UNITED STATES
NUCLEAR REGULATORY COMMISSION
WASHINGTON, D. C. 20555

OCONEE NUCLEAR STATION, UNIT NO. 1

AMENDMENT TO FACILITY OPERATING LICENSE

SAFETY EVALUATION BY THE OFFICE OF NUCLEAR REACTOR REGULATION
SUPPORTING AMENDMENT NO. 78 TO FACILITY OPERATING LICENSE NO. DPR-38

OCONEE NUCLEAR STATION
Figure 3.5.2-3B2

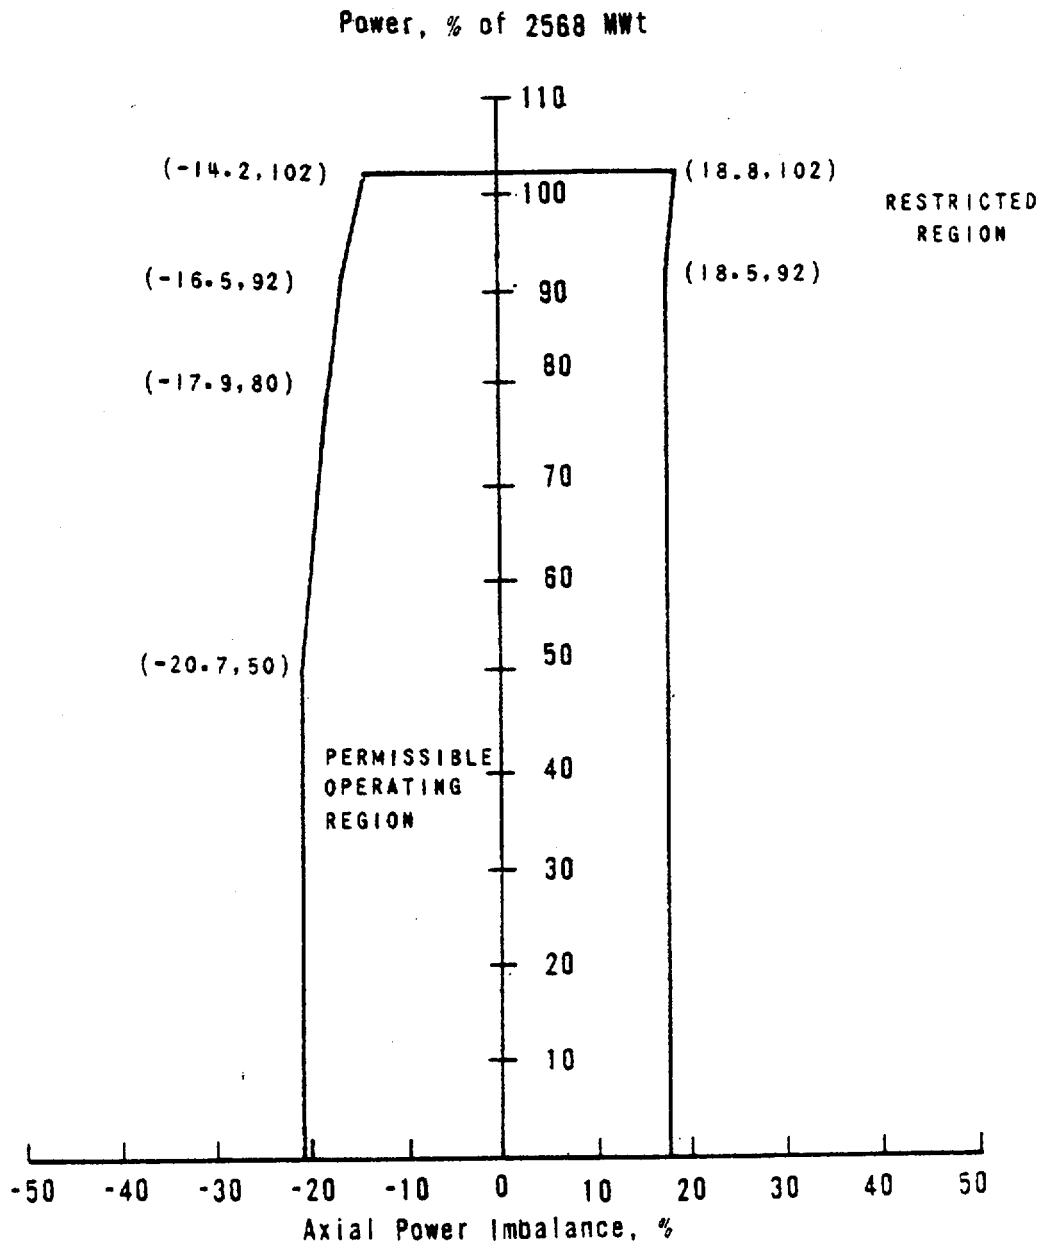
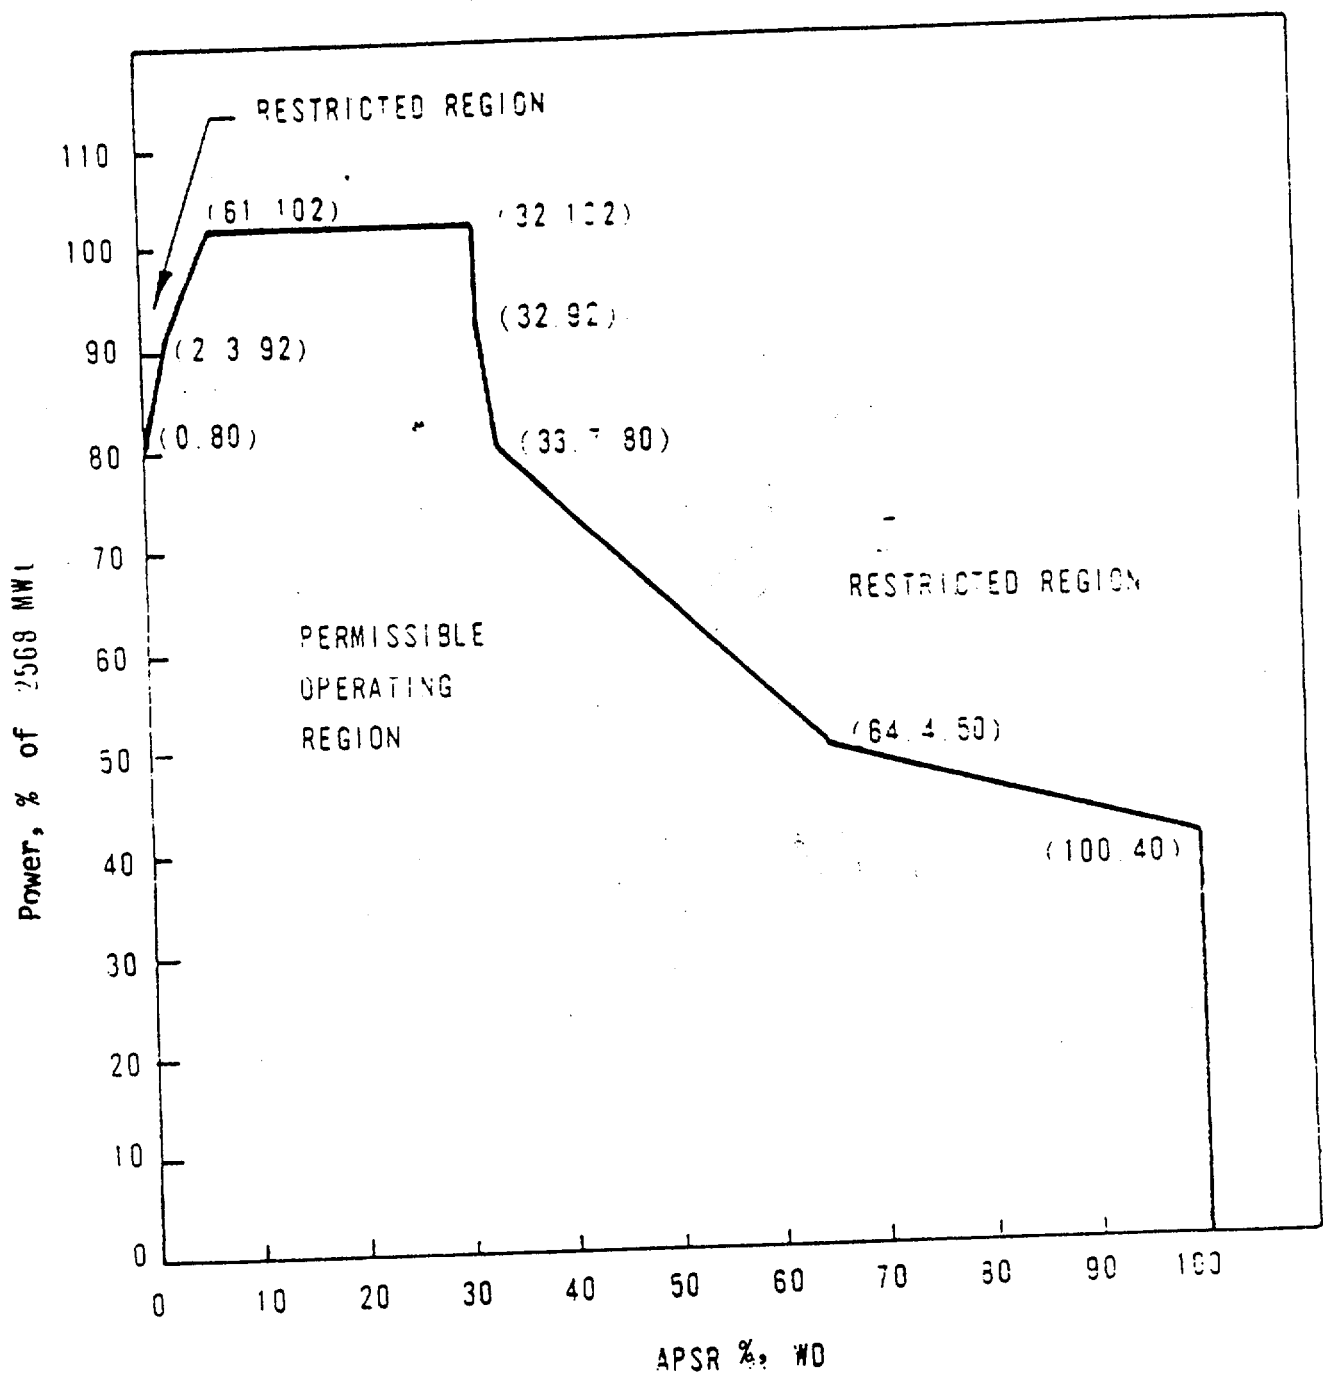
These amendments revise the core protection safety limits, protective system maximum allowable setpoints, control rod position limits, operational power imbalance envelope and axial power shaping rod position limits for Unit 2 consistent with extending the duration of the Unit's present operating cycle from 297 ± 10 to 363 effective full power days. Editorial changes have been included as discussed and accepted by your staff.

OPERATIONAL POWER IMBALANCE
ENVELOPE
FOR OPERATION
FROM 297 TO 363 EFPD
UNIT 2
OCONEE NUCLEAR STATION

Figure 3.5.2-4B2

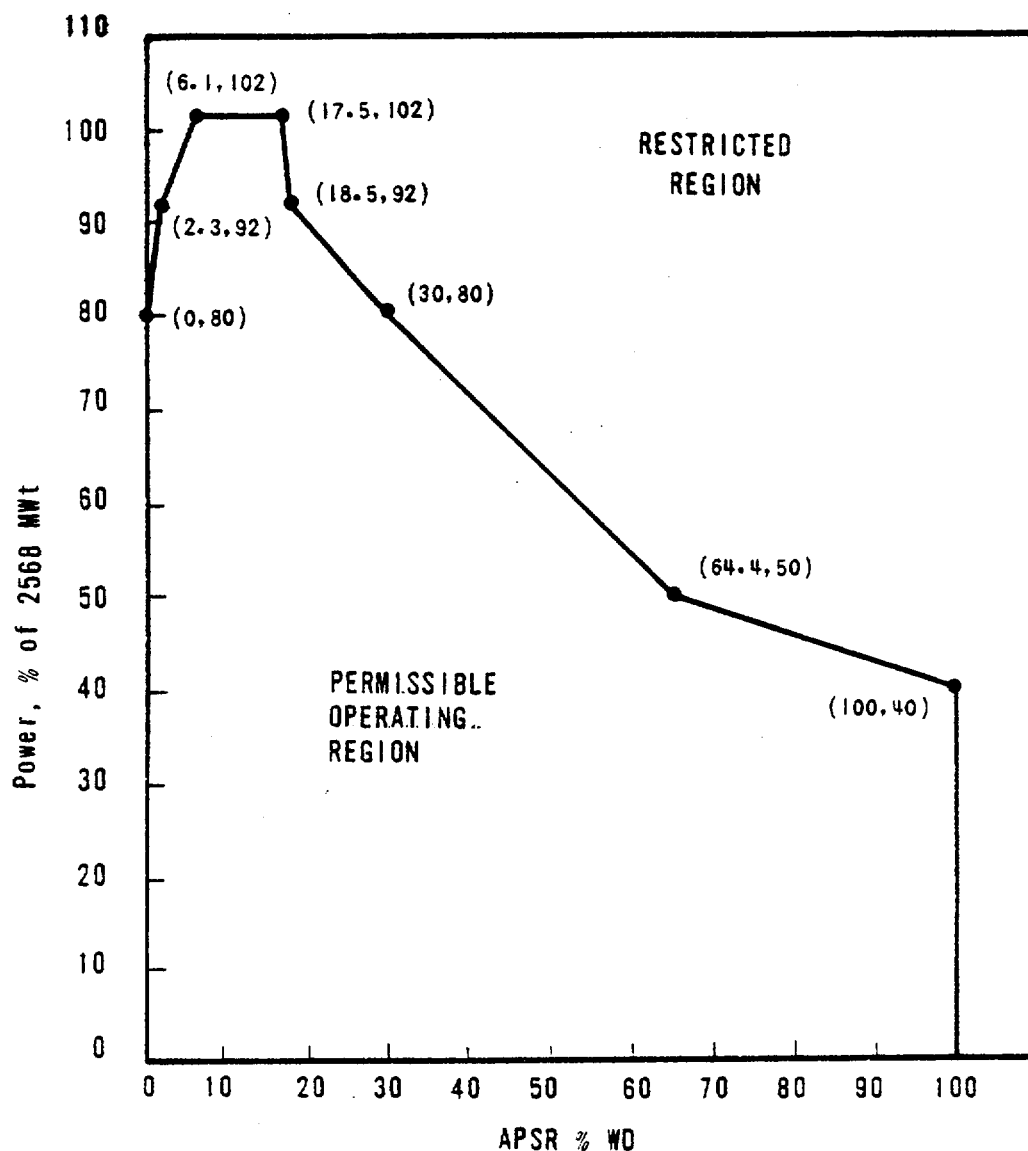
APSR POSITION LIMITS
FOR OPERATION
FROM 297 TO 363 EFPD
UNIT 2
OCONEE NUCLEAR STATION
